3. Rand Road

5. 1021 Westbrook Street

I am submitting the following comments, on behalf of the Engineering Division, regarding the Site Plan for the proposed AC Hotel project at 158 Fore Street. These comments are based on review of the Utility Plan (9/29/2015), Site Plan (9/29/2015), and Construction Details sheet C2.0 (9/29/2015).

TECHNOLOGY PARK UTILITY PLAN 1

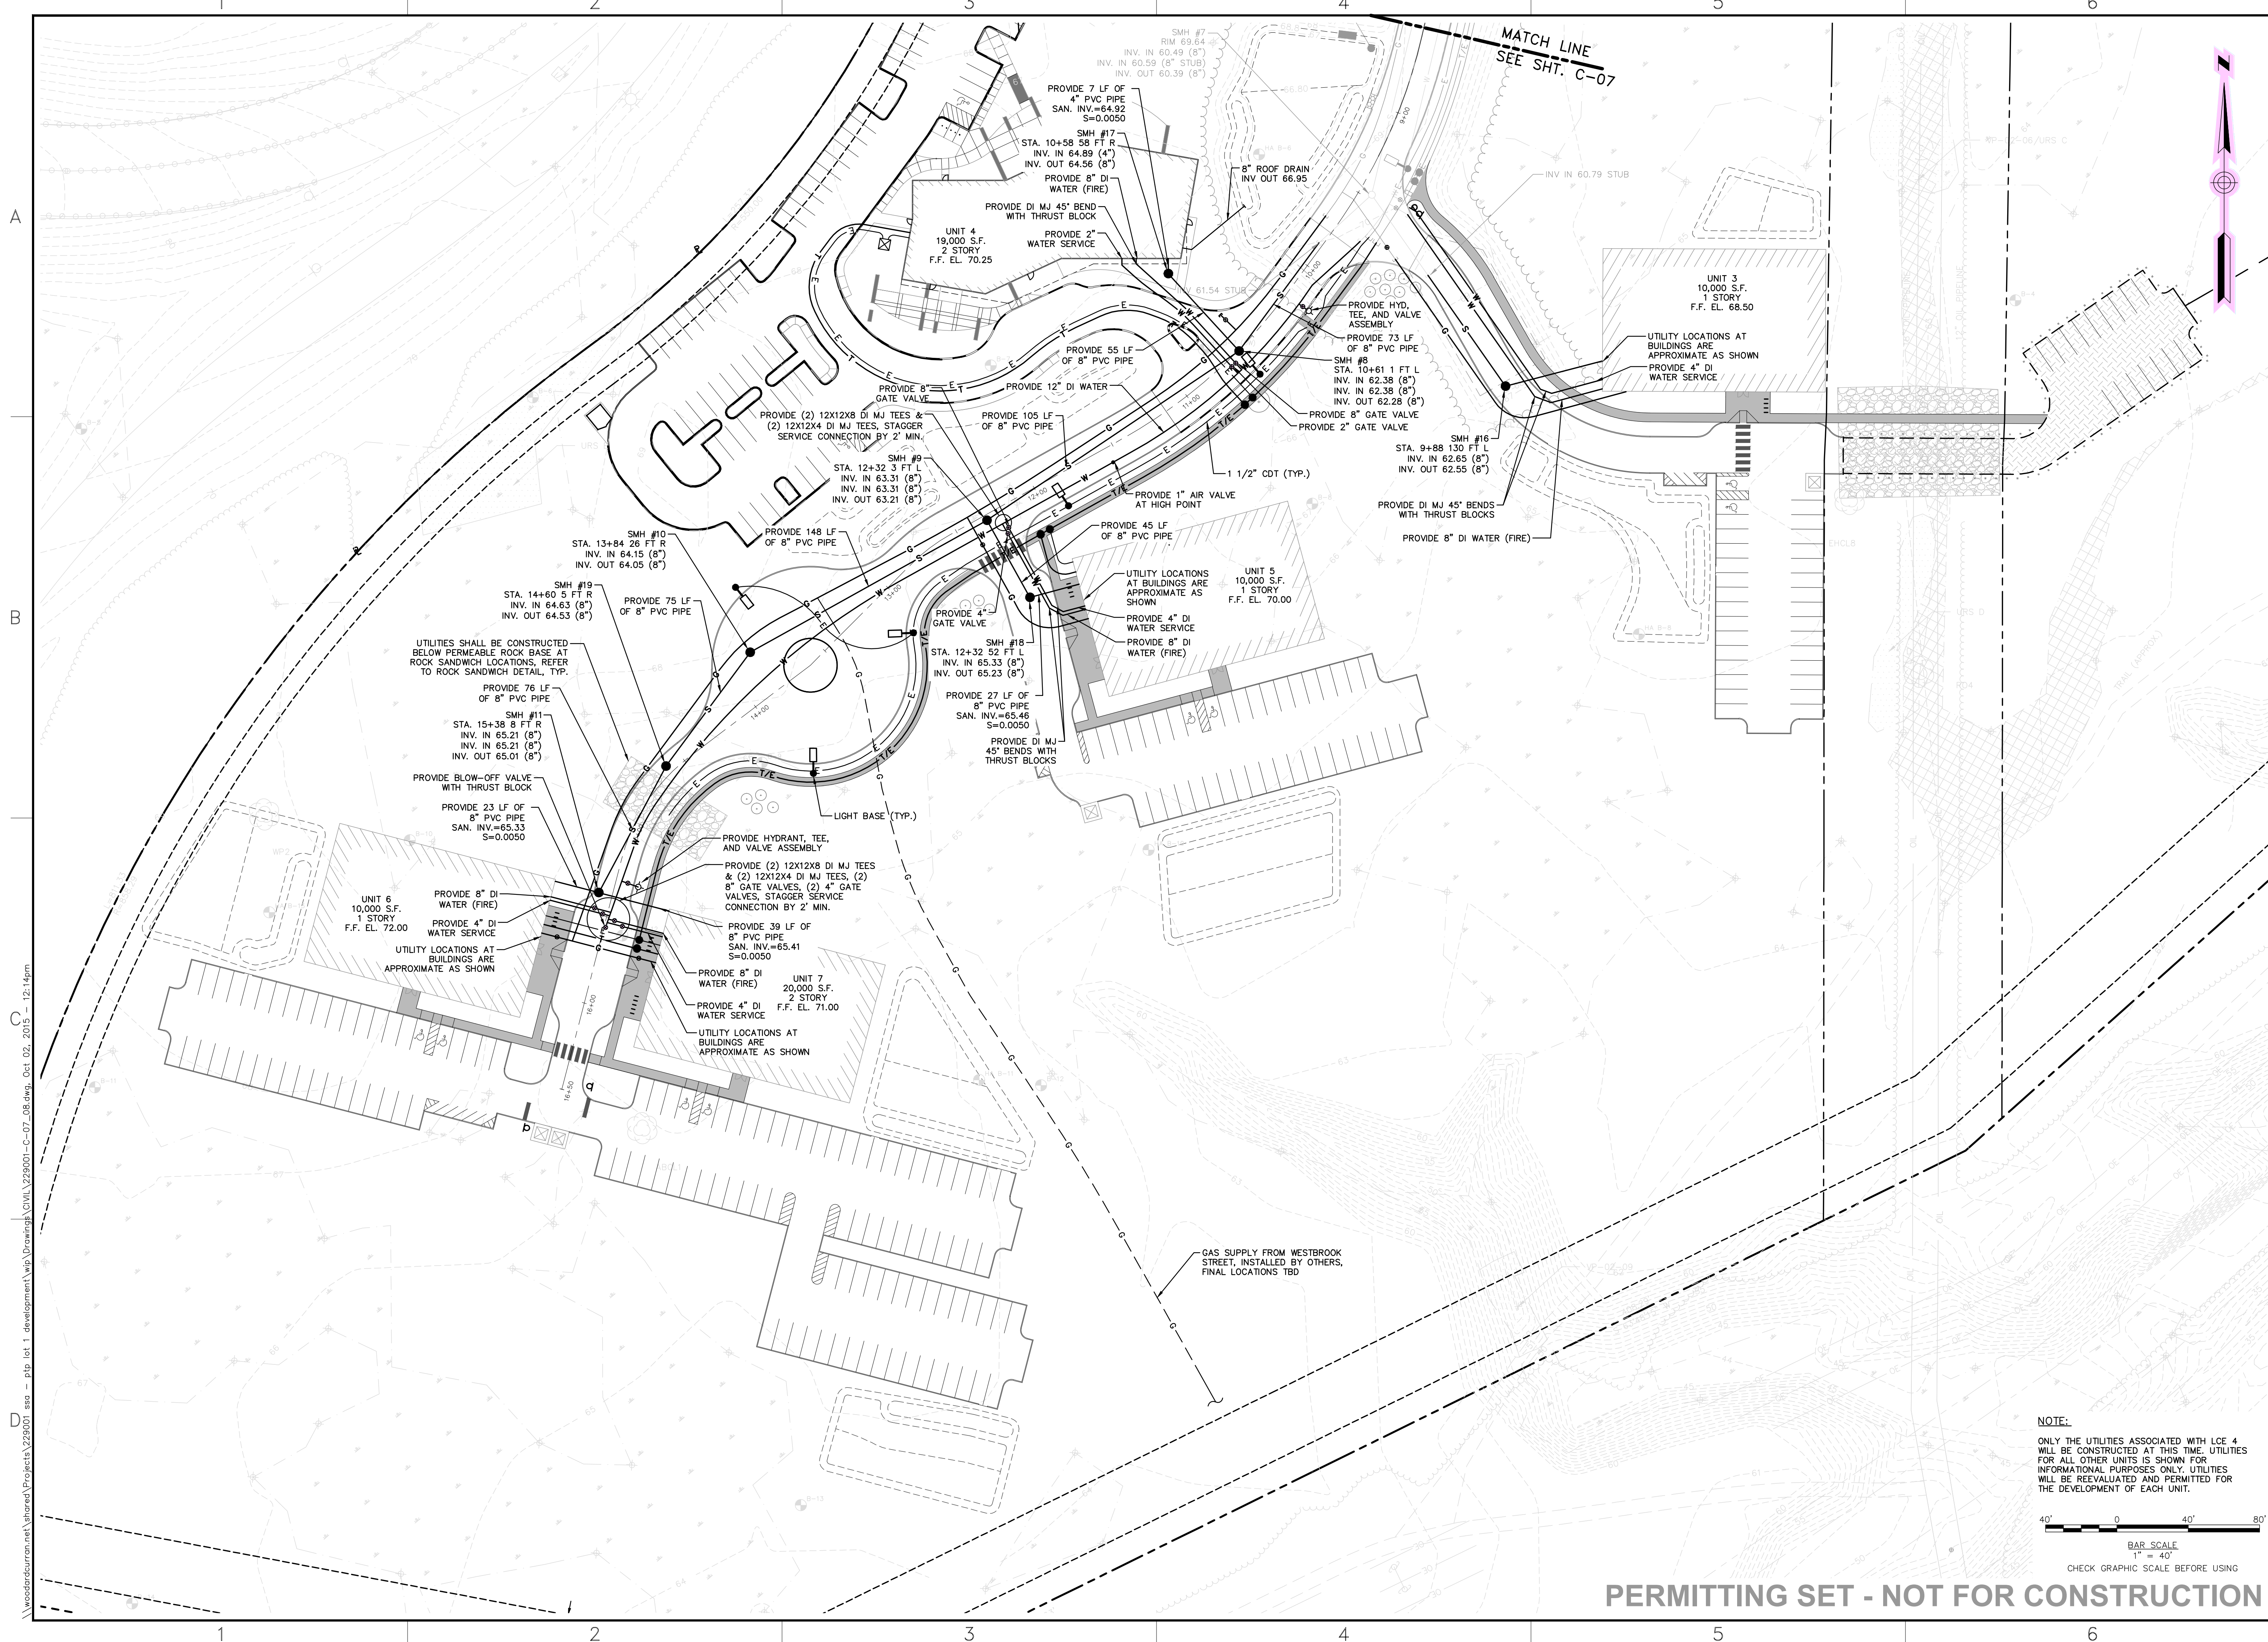
3. Sheet C-09 shall be modified to show the proposed 8" sanitary sewer between smh #7 and smh #8 to be install with a straight line and grade or show a new manhole on the stub extending from smh #7. If the stub is re-installed, the road shall be repaved to the point of disturbance.

C0.1

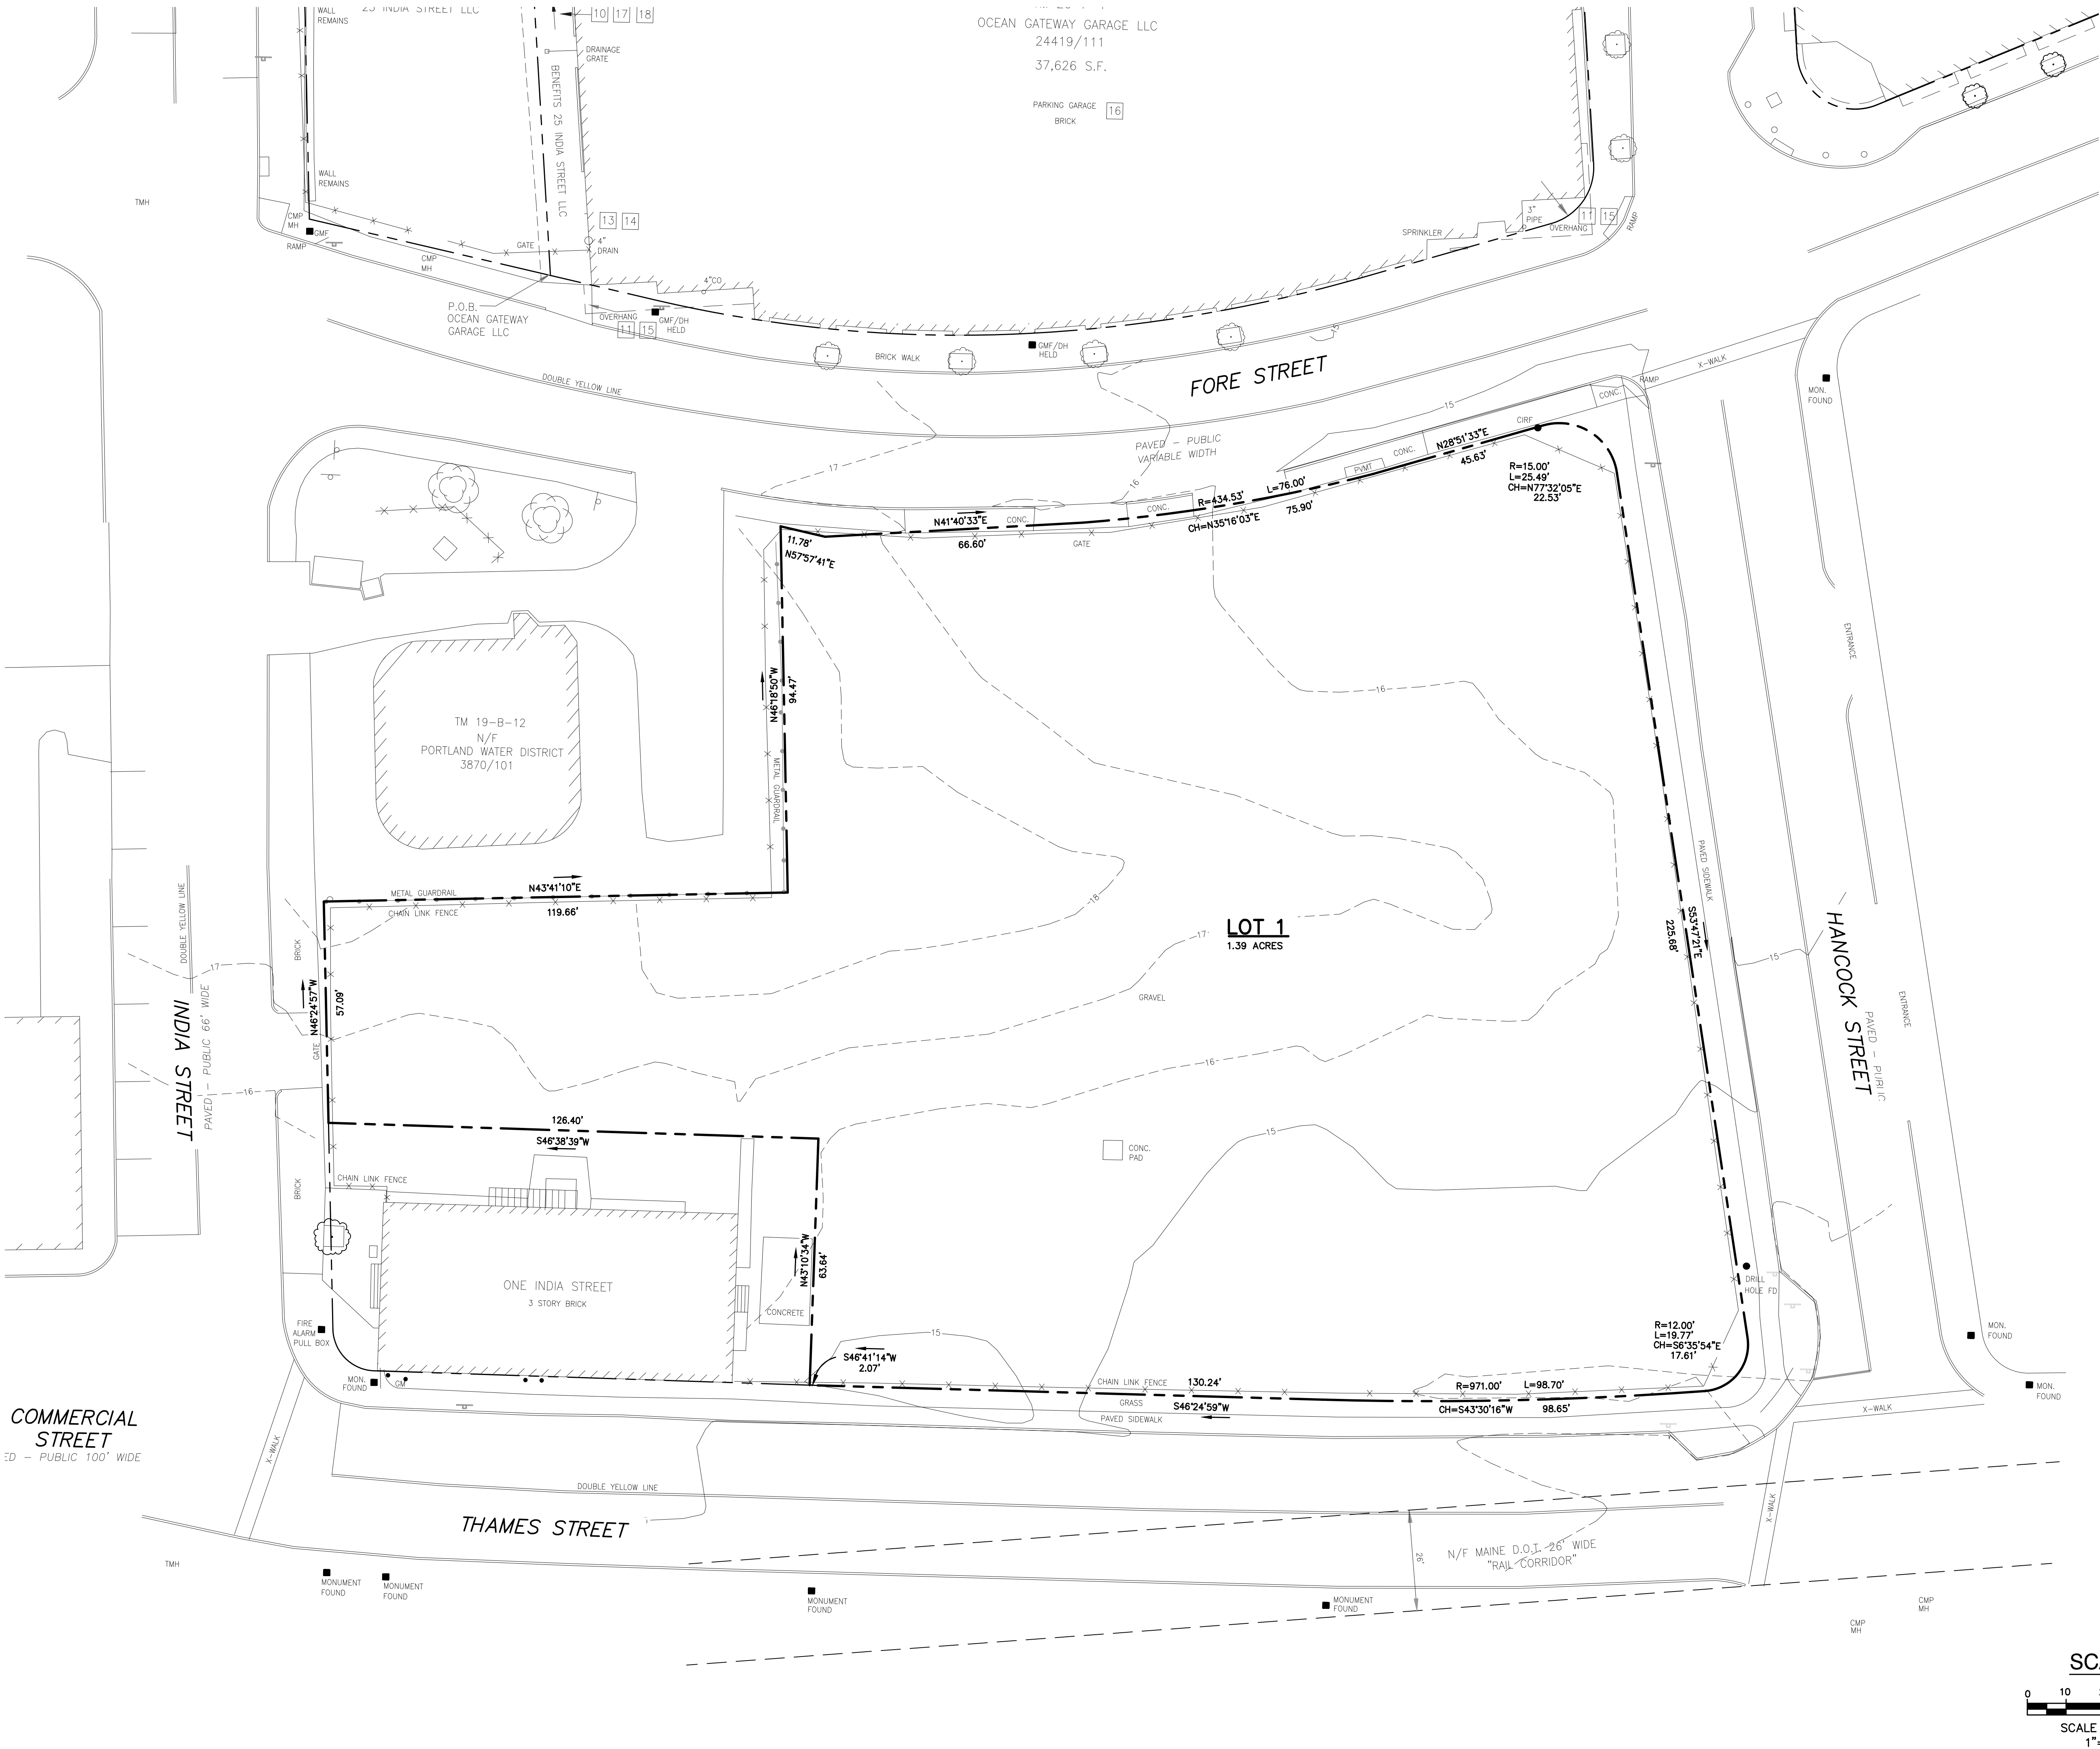
- a) Vertical Granite Curb;
 - b) Brick Sidewalk;
 - c) Brick Driveway Apron; and
 - d) ADA Pedestrian Ramps.
- 9) Sheet C-0.1 – Existing Conditions Plan – The existing conditions plan should show existing utilities in the adjacent roadways.

B	PRELIMINARY SUBMISSION	09/29/15
A	CLIENT REVIEW	09/15/15
No.	Revision/Issue	Date
Design by:	MPM	Checked by: SJB
Drawn by:	JAR	Approved by: SJB
Project:	150.06094	Date: AUGUST 2015
Sheet No:	C1.1

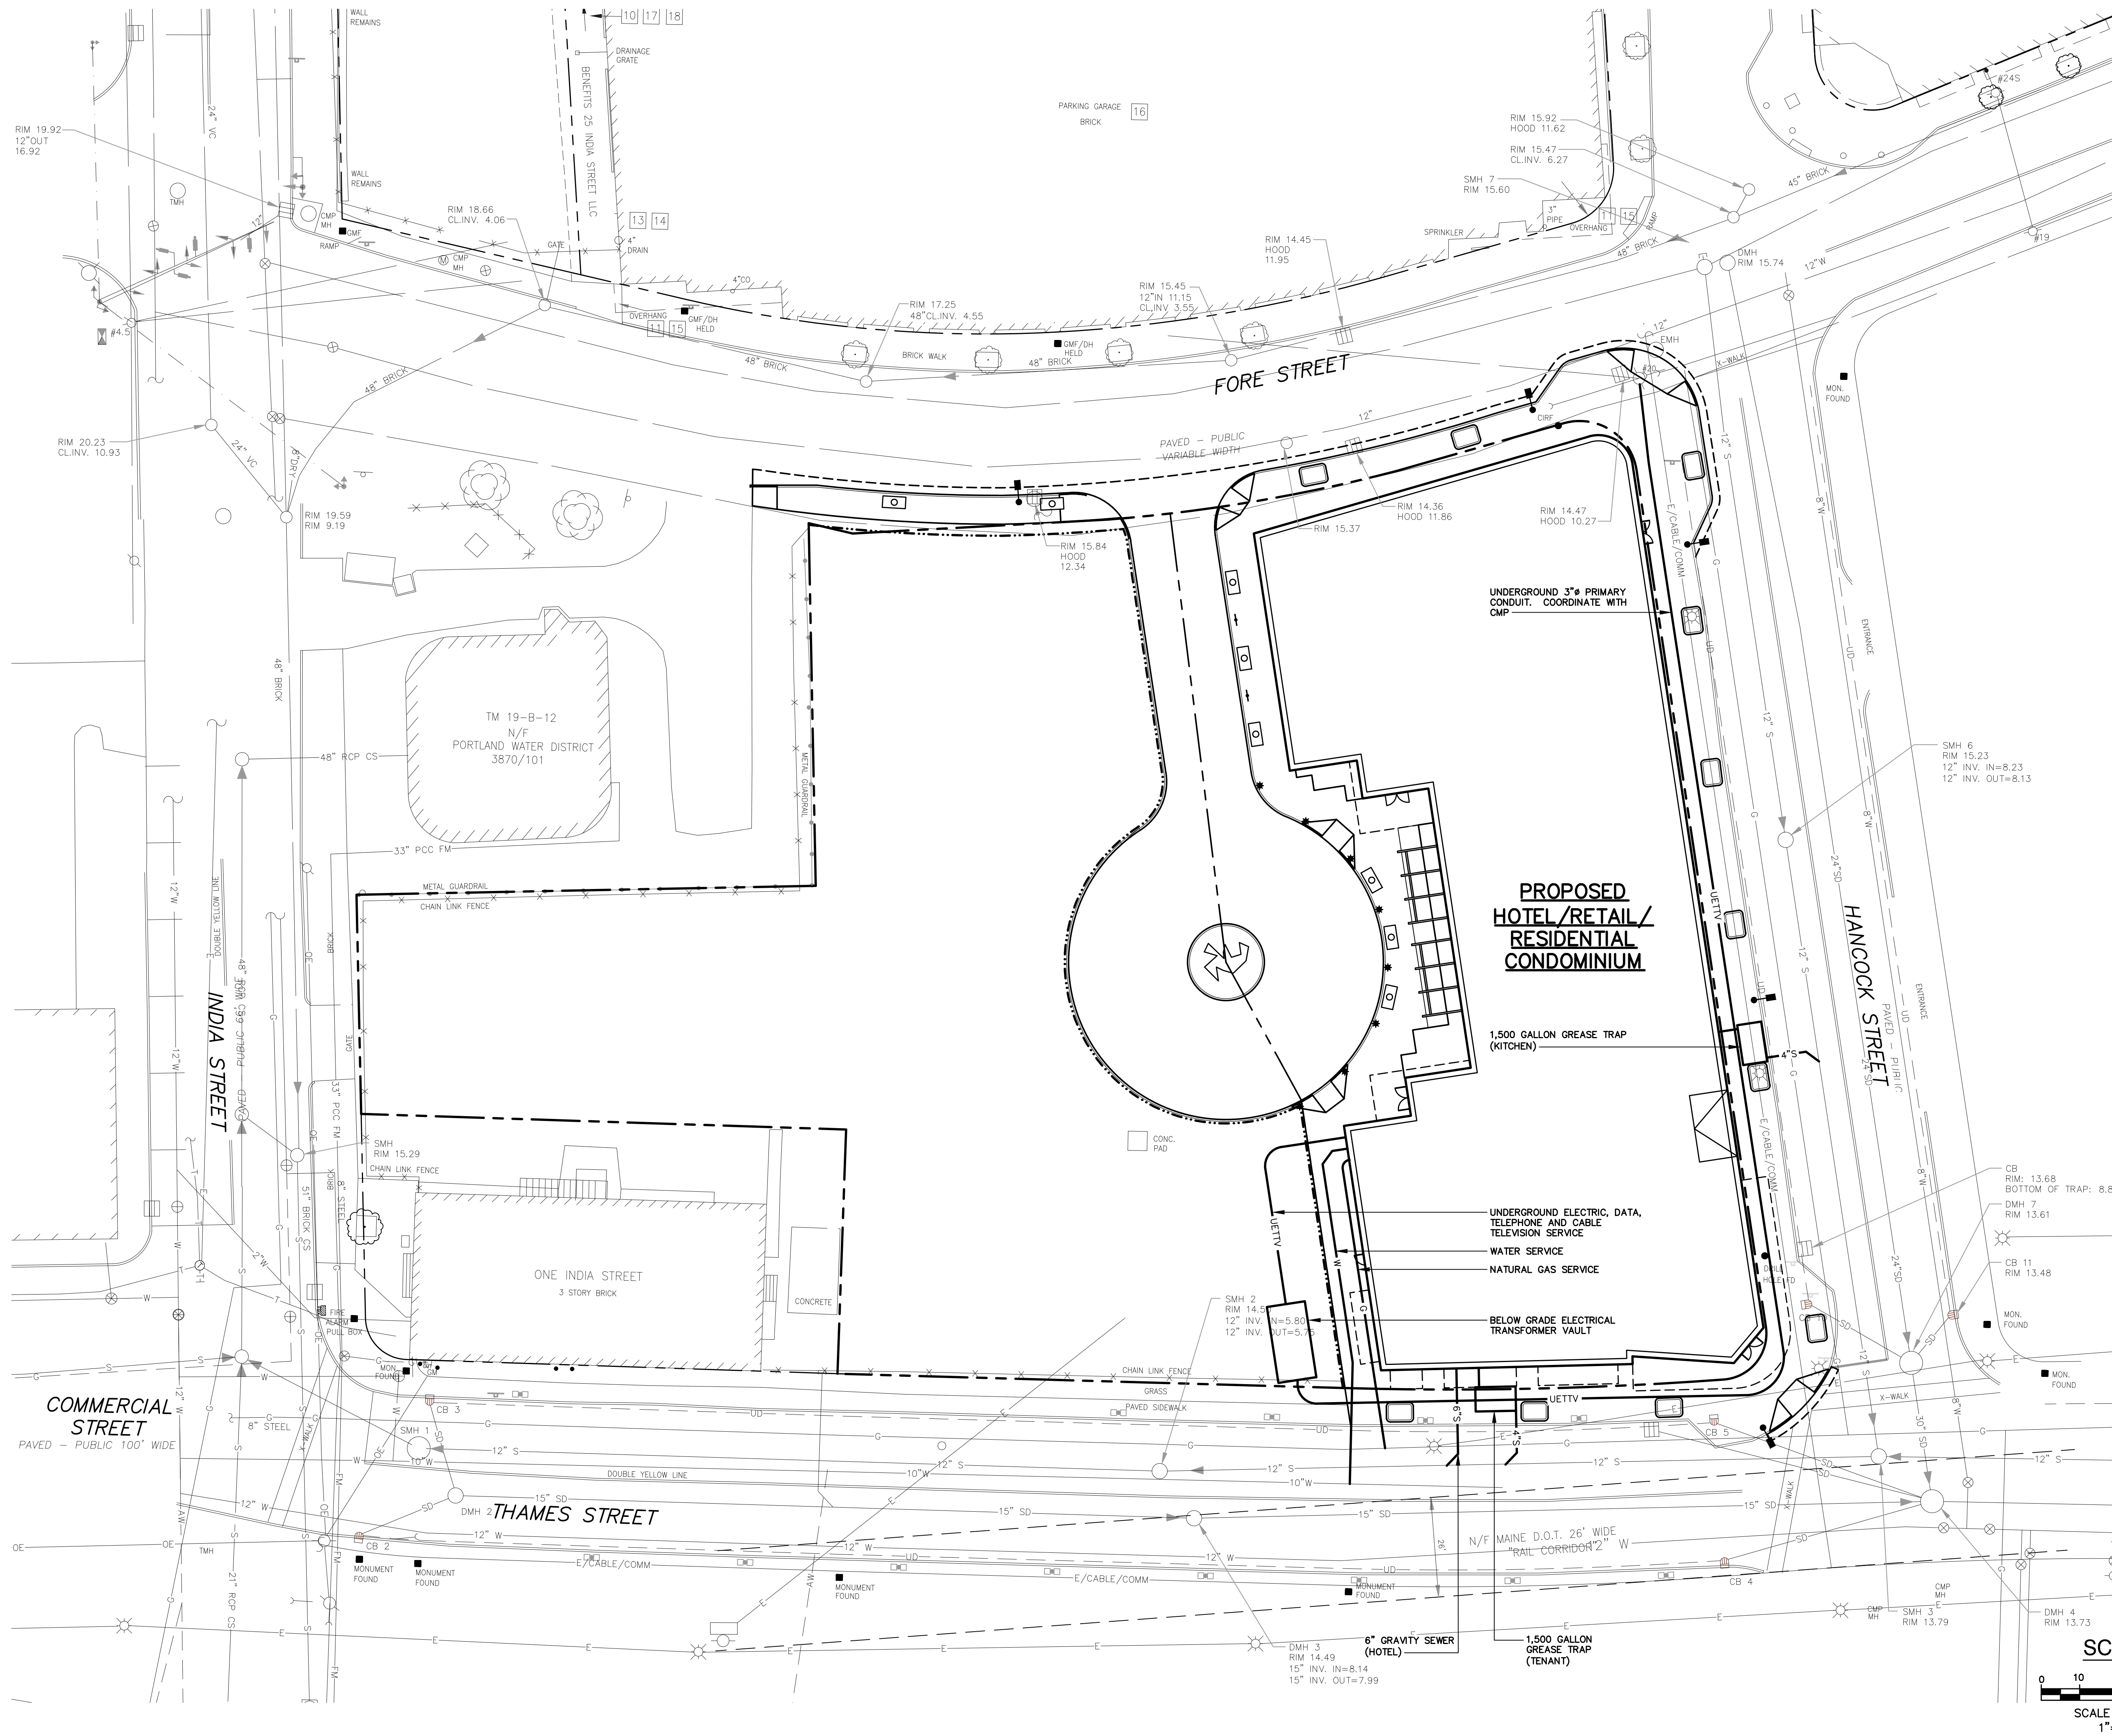
- 10) Sheet C-1.1 – Utility Plan
 - a) Two existing catch basins are shown in the sidewalk (CB5 & 10) at the intersection of Hancock and Thames; however, no catch basins exist in the sidewalk in this area.
